Access Compliance Report

Public Rights-of-Way

(Curb Ramps)

Intersection ID: 17140	Main Street: S_WENDOVER_RD	Cross Street: SEDGEWOOD_CR	Location: SW
ADA ID: 88193A373229	Ramp Type: PerpDiag	Initial Pass/Fail: Fail	Overall Compliance: No
Severity Score: 22.5			
Codes/Mitigation Info/Possible Solution		Field Measurements/Component Compliance

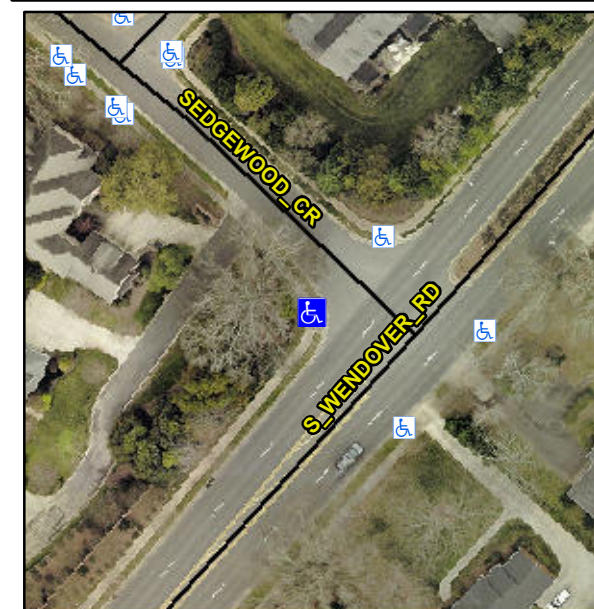
Not Found, R304.5.1, R304.2.2, R304.5.3

Compliance	Description	Data	Compliance	Description	Data
N/A	Ramp Length (in)	48.0	No	Ramp Slope (%)	11.2
No	Ramp Width (in)	43.0	No	Ramp XSlope (%)	2.6
N/A	Flare Type LT	N/A	N/A	Flare Type RT	N/A
N/A	Flare Slope LT (%)	N/A	N/A	Flare Slope RT (%)	N/A
N/A	Flare Traversable LT?	N/A	N/A	Flare Traversable RT?	N/A
N/A	Landing Length (in)	N/A	N/A	DWS Provided?	N/A
N/A	Landing Width (in)	N/A	N/A	DWS Contrast?	N/A
N/A	Landing Slope (%)	N/A	N/A	DWS Length (in)	N/A
N/A	Landing X Slope (%)	N/A	N/A	DWS Full Width?	N/A
N/A	Landing Curb? (Y/N)	N/A	N/A	DWS Offset (in)	N/A
N/A	Shared Landing?	N/A			
N/A	Gutter Ponding?	N/A	N/A	Gutter Slope (%)	N/A
N/A	Gutter Lip Ht (in)	N/A	N/A	Gutter X Slope (%)	N/A
N/A	Painted X Walk1?	No	N/A	Painted X Walk2?	No
	X Walk 1 Direction	To SE		X Walk 2 Direction	To NE
N/A	X Walk 1 Width (in)	N/A	N/A	X Walk 2 Width (in)	N/A
	X Walk 1 Slope (%)	0.3		X Walk 2 Slope (%)	3.8
	X Walk 1 X Slope (%)	1.5		X Walk 2 X Slope (%)	2.5

Remove & Replace Curb Ramp With Two New Directional Ramps or Equivalent.
